Re: 40B - 120 Turnpike Road 40B Apartment Bldgs. Questions and Comments

Dated: October 6, 2024

From: Paul Carter, P.E. Town Resident 6 Hillside Avenue

Board of Appeals Public Hearing 10/8/24

EXHIBIT - 9/3/24
BLDG HEIGHT (# OF STORIES)
VS BLDG FOOTPRINT

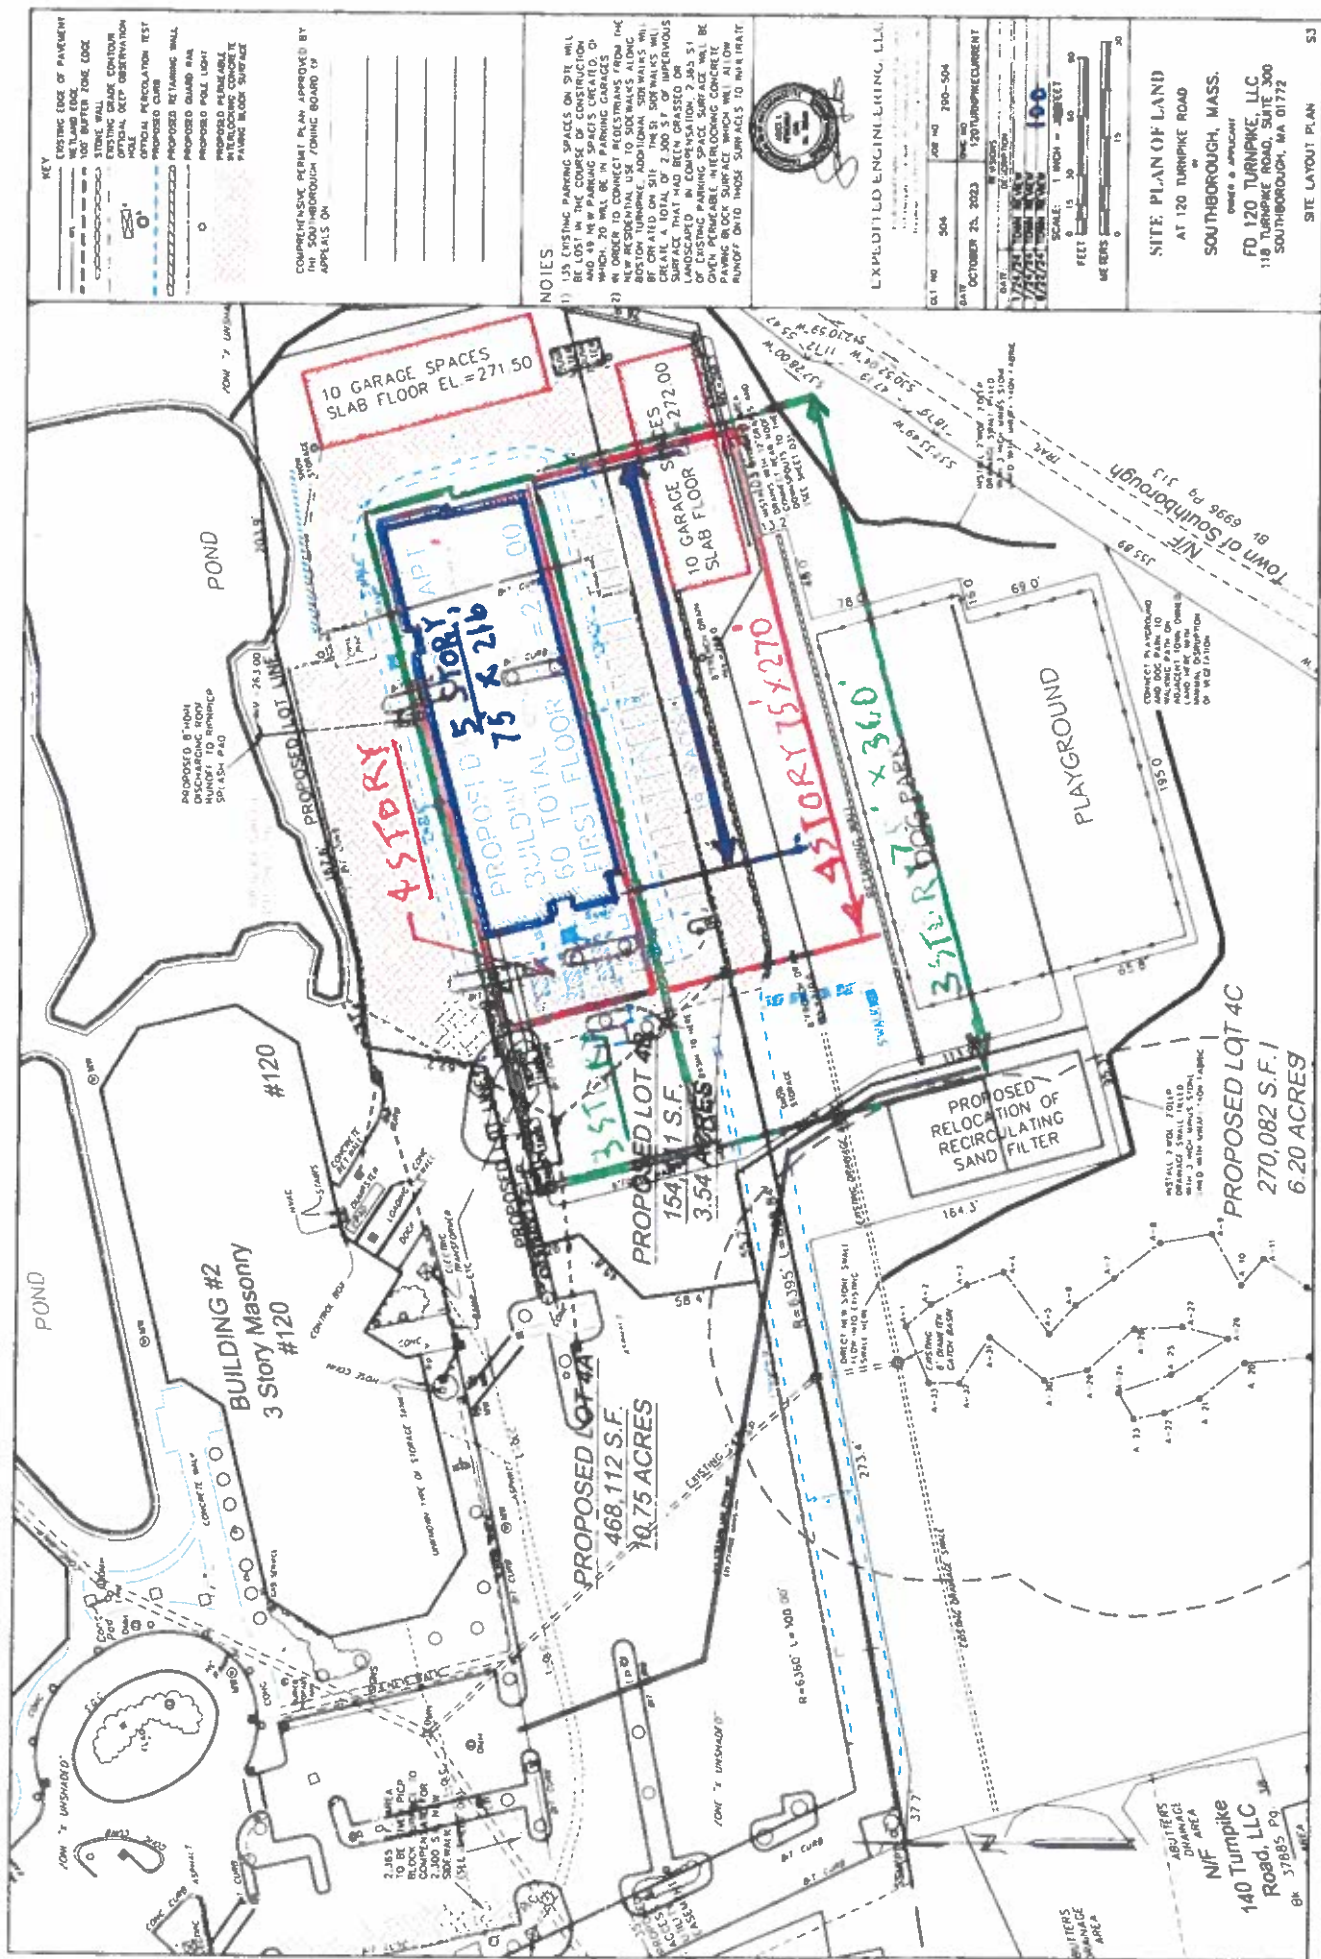
- ii. In order to clearly show this relationship rather than just talk about it, attached is a sketch entitled Exhibit 1 that shows exactly the additional length of the building that would be needed to attain the same desired square footage of 81,000 square feet that is proposed for the 5 story building. For a 4 story building, the building length would need to be an additional 54 feet long. For a 3 story building, the building would need to be an additional 144 feet long.

- iii. Clearly the footprint of a 4 story building would not have a cost prohibitive impact on the project site plan. The only impact of the increased footprint required for a 3 story building would be on parking which could probably worked out.

- vii. I recommend that the building height issue be properly addressed before the project is allowed to move forward.
